**OFFICE OF RATEPAYER ADVOCATES  
CALIFORNIA PUBLIC UTILITIES COMMISSION**

**REPORT ON PLANT – REGION 3  
Golden State Water Company  
Test Year 2016 General Rate Case  
A.14-07-006**

# Report on Plant – Region 3

Figure 1-J: Claremont CSA – Well Data

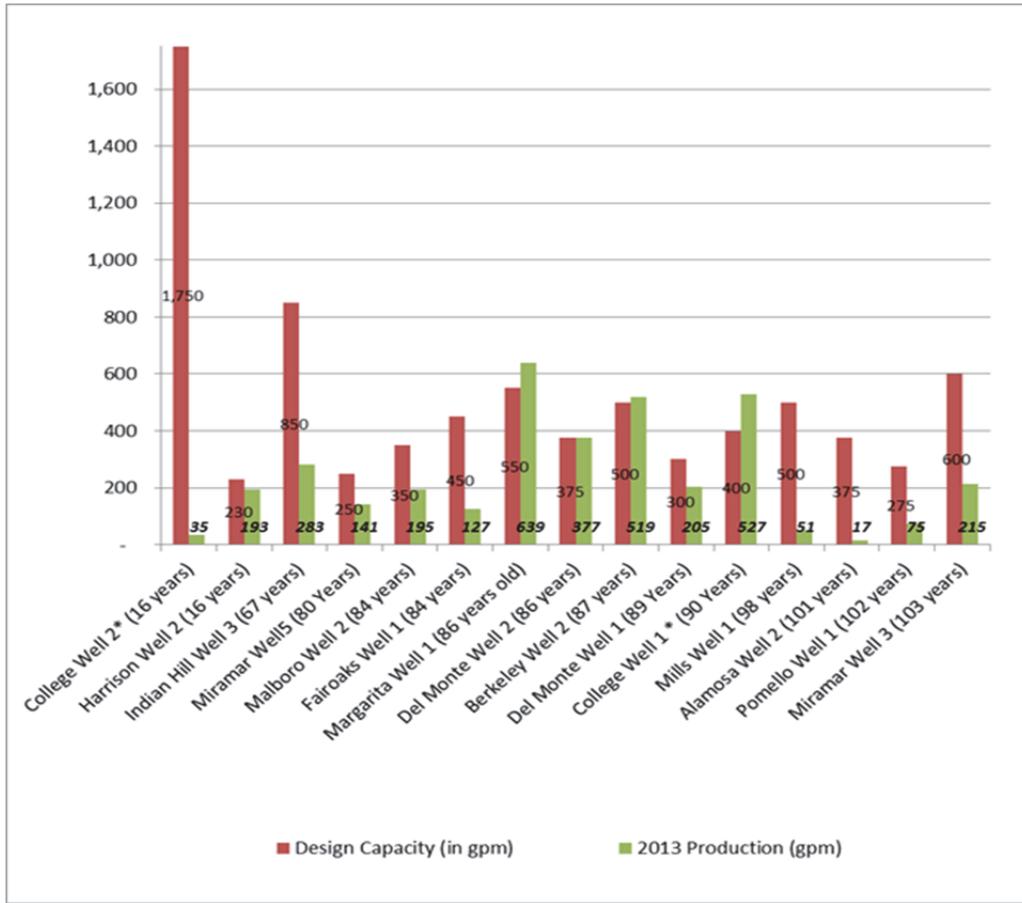
8 GSWC asserts that the system's lost capacity is attributed to wells nearing the end of their useful  
9 life and that the new replacement well is required to replace the lost capacity of GSWC's aging  
10 wells. **Figure 1-J** shows the current 15 active wells including their respective age, design  
11 capacity, and 2013 average production in the Claremont system.<sup>75</sup> **Table 1-K** presents the same  
12 information plus "well efficiency"<sup>76</sup> data.

2 The data from both **Figure 1-J** and **Table 1-K** indicates that the age of a well does not always  
3 correlate with its productivity, at least not in the Claremont CSA. To find out the factors that  
4 could cause low water production, ORA asked GSWC to explain the discrepancy between the  
5 design and production capacity. GSWC responded as follows:

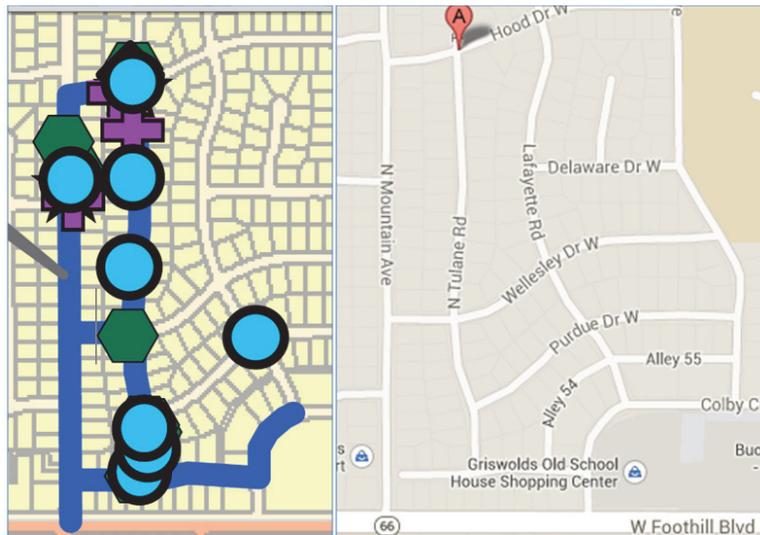
19 In GSWC's response to ORA's data request, GSWC provided detailed leak information that  
20 indicated there were 28 instead of 25 leaks as GSWC stated in its workpapers.<sup>103</sup> Information on  
21 the 28 leaks are shown in the following table and maps (the Google map, on the right, is  
22 provided by ORA to add details to GSWC's leak map.)

GSWC Leak Map

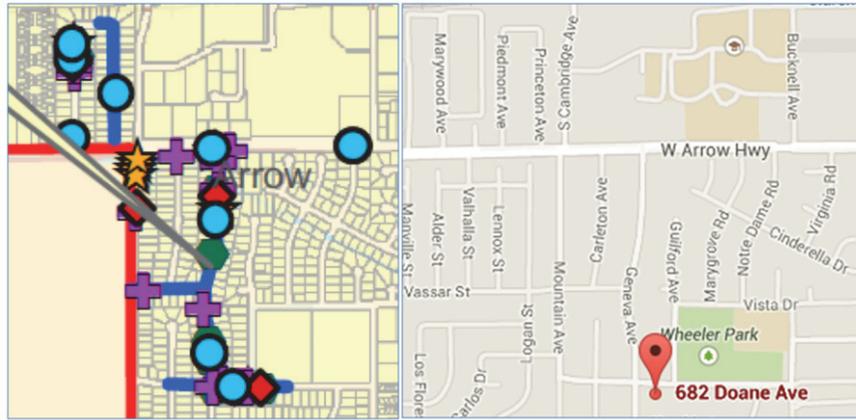
2	3/31/2010	2010	702 W Arrow Hwy on Geneva	Pinhole - Corrosion
3	4/28/2010	2010	702 W Arrow Hwy on Geneva	Pinhole - Corrosion
4	2/9/2012	2012	702 W Arrow Hwy on Geneva	Pinhole - Corrosion

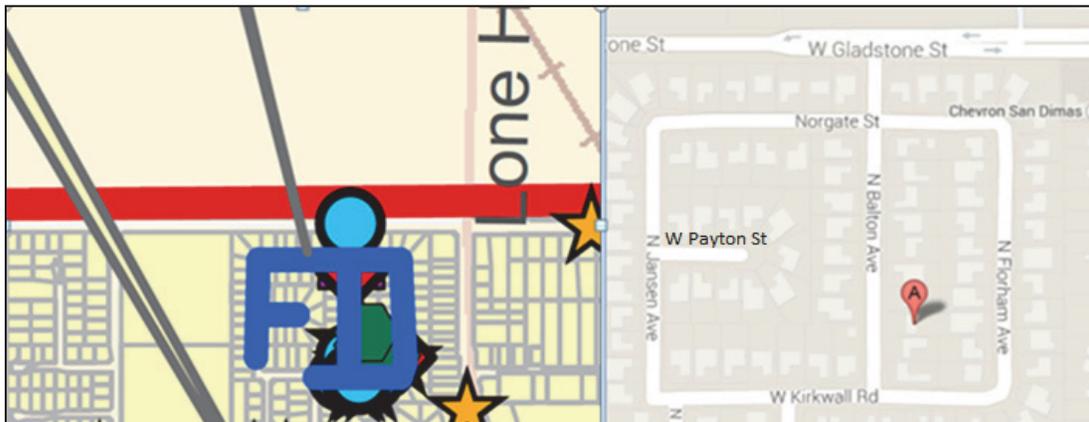
10 In GSWC’s response to ORA’s data request, GSWC provided the following leak information  
11 showing there were actually only 23 instead of 31 leaks as GSWC stated in its workpapers.<sup>125</sup>  
12 (The Google map, on the right, is provided by ORA to add details to GSWC’s leak map.)

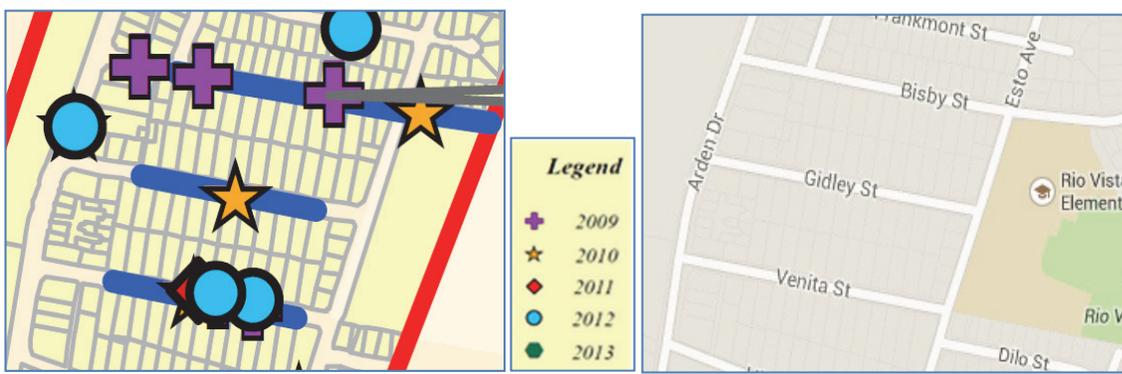
21 In GSWC’s response to ORA’s data request, GSWC provided the following leak information  
22 showing that there were actually only 11 leaks instead of the 15 leaks that GSWC stated in its  
23 workpapers.<sup>132</sup> For 2009 and 2010, GSWC did not provide information on the type and  
24 description for leaks.

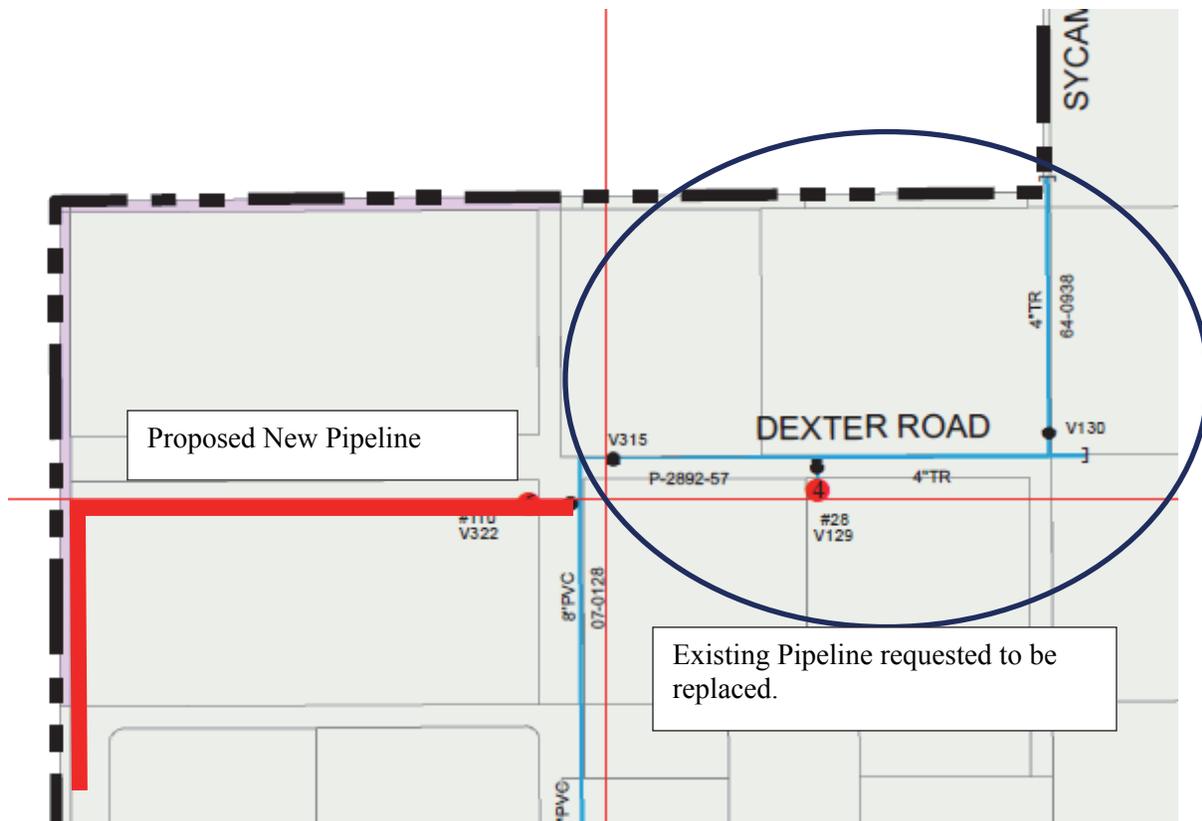
10 The following system map, clipped from Apple Valley North System Wall Map, better illustrates  
11 the locations of existing pipeline and the proposed pipeline installations described in the project  
12 justification, with ORA’s notations.<sup>157</sup>

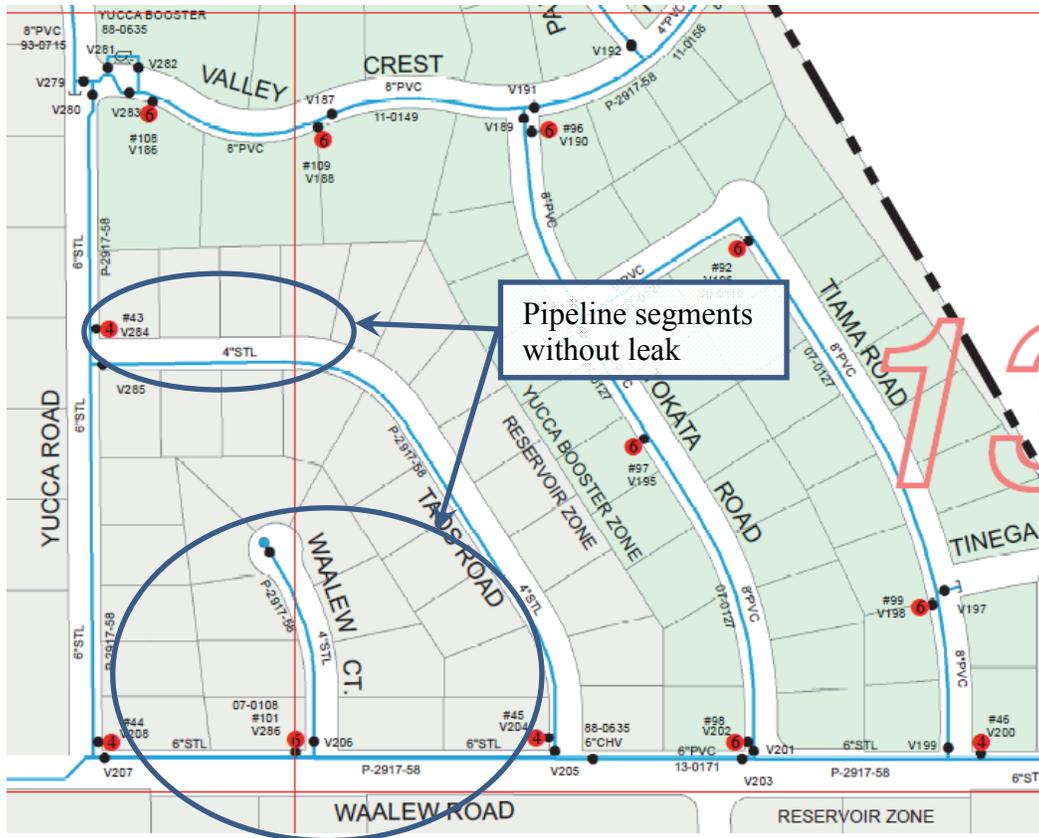
1 ORA finds the number of leaks on some of the pipeline segments warrants replacement.  
 2 However, GSWC also requests replacing segments of pipeline that did not have any leak history.  
 3 Specifically, the 4-inch steel pipeline along Waalew Court, the west to east run of 4-inch steel  
 4 pipeline along Taos Road, and the 6-inch steel pipeline in Waalew Road between Yucca Road  
 5 and Waalew Court have not had any leaks. The street names and the existing pipelines are better  
 6 illustrated in the following system map, with ORA's notations:<sup>169</sup>

7  
 8 It is prudent to replace only the segments with a leak history. According to GSWC's PMP  
 9 Report, steel pipes can last as long as 68 years in Apple Valley area.<sup>170</sup> Given the age (56 years)  
 10 of the pipelines, segments that have had no leaks should be monitored, not replaced.

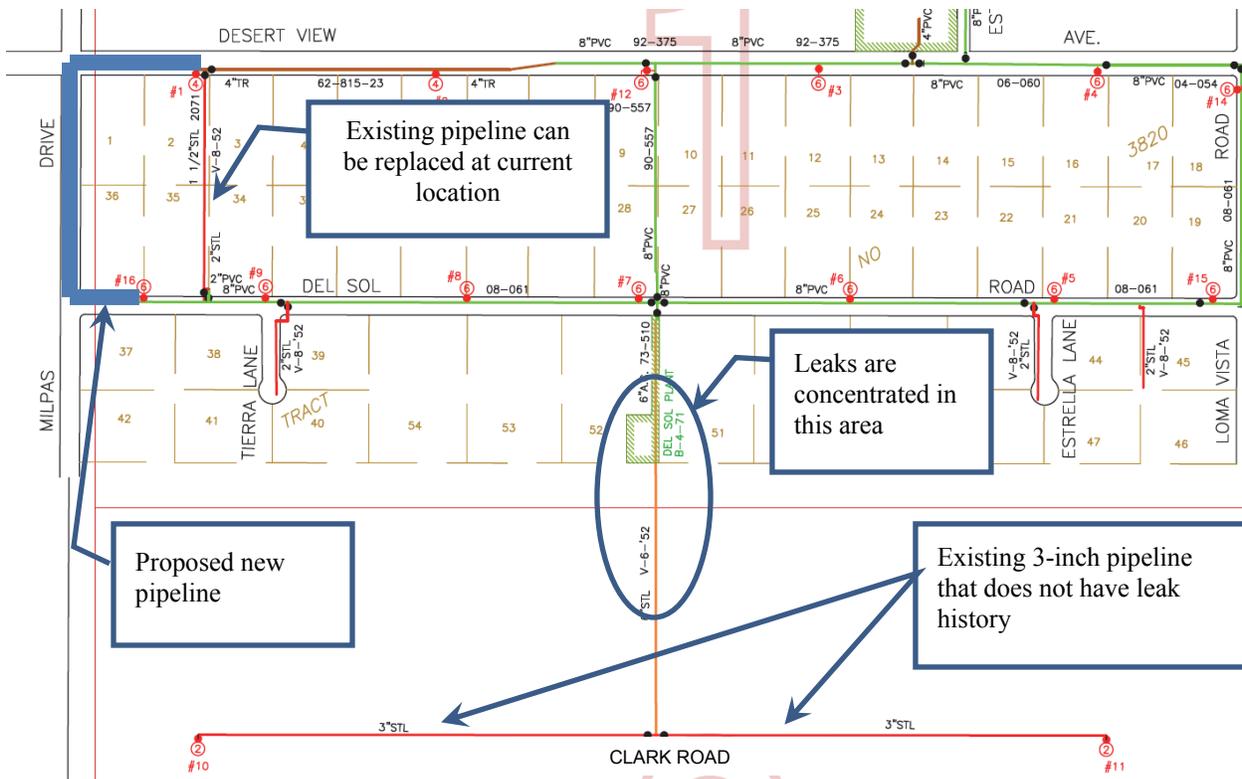
1 Similar to previously discussed projects, GSWC requests replacing pipelines that do not have  
 2 leaks. Specifically, the 3-inch steel pipeline along Clark Road and 2-inch steel pipelines along  
 3 Tierra Lane and Estrella Lane have not had any leaks. GSWC also requests installing a new  
 4 pipeline along the Milpas Road and Desert View Road instead of replacing the existing pipeline  
 5 at the current location. The street names and the existing pipelines are better illustrated in the  
 6 system map below, with ORA's notations:<sup>177</sup>

1 **Figure 2-A: Bradshaw wells directly supply the Bear Valley Zone**<sup>193</sup>

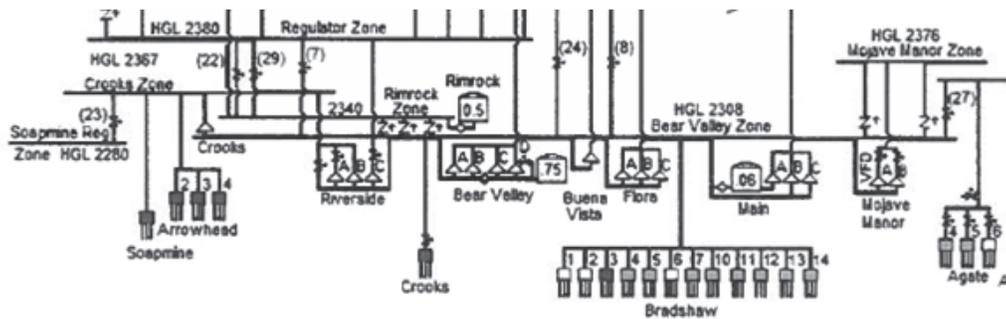
11 As shown in **Figure 2-A** below, the Bradshaw wells directly supply the Bear Valley Zone only.  
12 The Bear Valley Zone is also supplied by Crooks Well, which is currently in service. However,  
13 GSWC elected not to consider the Crooks Well’s capacity (1,500 gpm) in its supply-demand  
14 analysis.

Figure 2-B: System Schematic around the Eaton and Lenwood Zone<sup>203</sup>

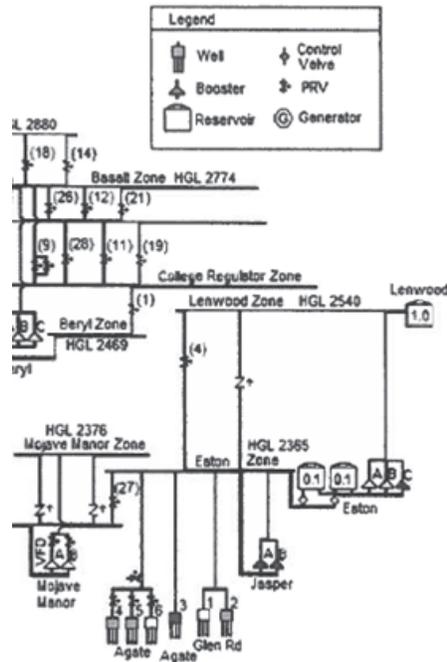
3  
 4 As presented in **Figure 2-B** below, the Eaton Zone is supplied directly by five wells: Agate  
 5 Wells No. 4, 5, 6, and Glen Road Wells No.1 and 2. The Eaton Zone’s demands (ADD, MDD,  
 6 and PHD) can be met by these wells’ capacity. Additionally, the Zone’s Maximum Day Demand  
 7 plus Fire Flow (MDD+FF) demand scenario is also met with the wells’ capacity plus the existing  
 8 Eaton Tanks (0.21 MG) storage capacity.

6 claims on the storage deficiency may be true. However, as presented above in **Figure 2-B** and

**Figure 2-C: Morongo Del Norte System Schematic<sup>240</sup>**

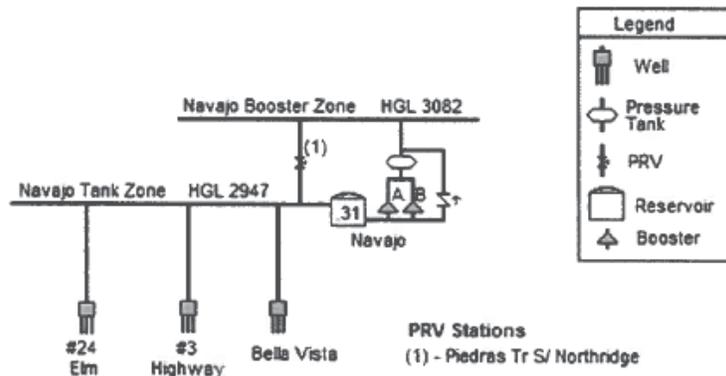
3 **Figure 2-C** below shows that all wells in the Morongo Del Norte System supply directly to  
 4 Navajo Tank Zone. The Navajo Booster Zone's (a zone adjacent to and at higher gradient than  
 5 the Navajo Tank Zone) supply depends on the Navajo Boosters' capacity. Thus, the source  
 6 capacities of the wells only affect the Navajo Tank Zone.

**Figure 2-D: Morongo Del Norte System’s Decreasing Demand Trend**

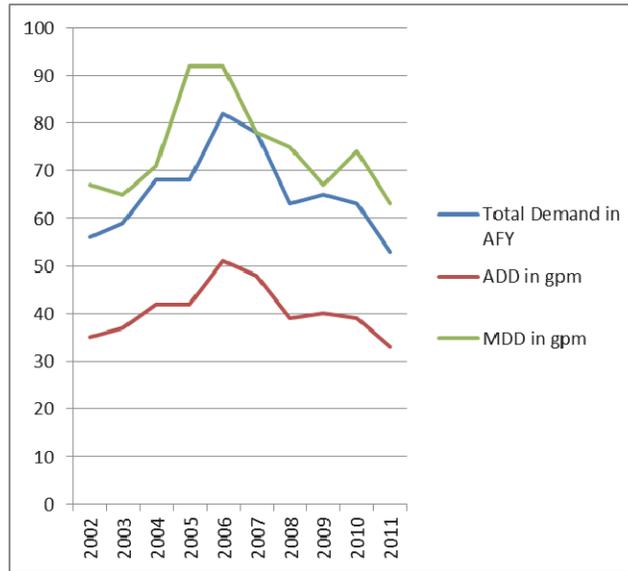
- 4 • Although the existing capacity of the Navajo Tank is 0.35 MG, GSWC only uses a  
5 portion of the total capacity. ORA uses the full capacity of the Navajo Tank in its  
6 analysis.
- 7 • For MDD, GSWC uses 92 gpm and ORA makes a modest adjustment and uses a slightly  
8 lower 90 gpm to reflect the clear and significant downward trend in historical water  
9 demand in the system as demonstrated in **Table 2-S** and **Figure 2-D** below.

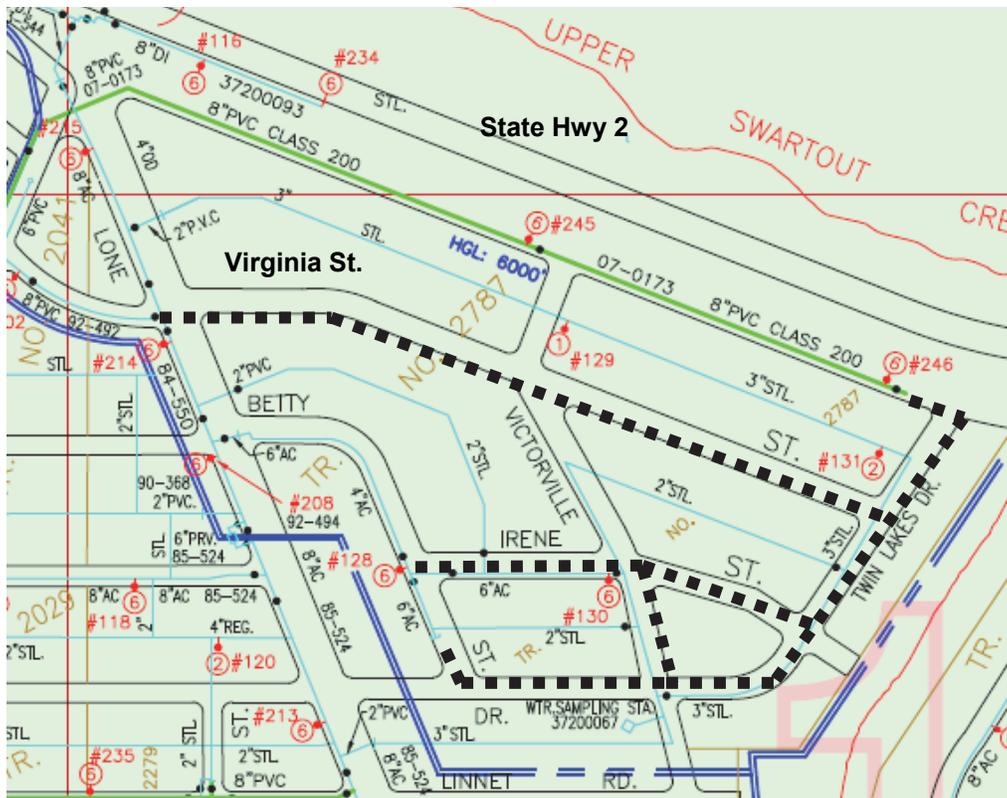
21 However, GSWC’s response to ORA Data Request DK4-001 states that there were only 8 leaks  
22 in 2009-2013. GSWC’s response to ORA Data Request BYU-005 provided the following leak  
23 map:

1 As shown in the above leak map, the pipeline along Virginia Street shows a history of repeated  
 2 leaks that ORA considers a reasonable justification for pipeline replacement. However, included  
 3 in the pipeline replacement request are some segments that have not had any leaks. According to  
 4 GSWC's project description in the workpaper, and comparing that with the existing pipeline  
 5 locations identified in the Wrightwood Wall Map below, ORA found that GSWC's request also  
 6 includes relocating the existing pipelines from backyards to the streets.<sup>260</sup> The scope of this  
 7 project is better illustrated in the following map. The dashed lines indicate GSWC's proposed  
 8 pipeline replacement projects.
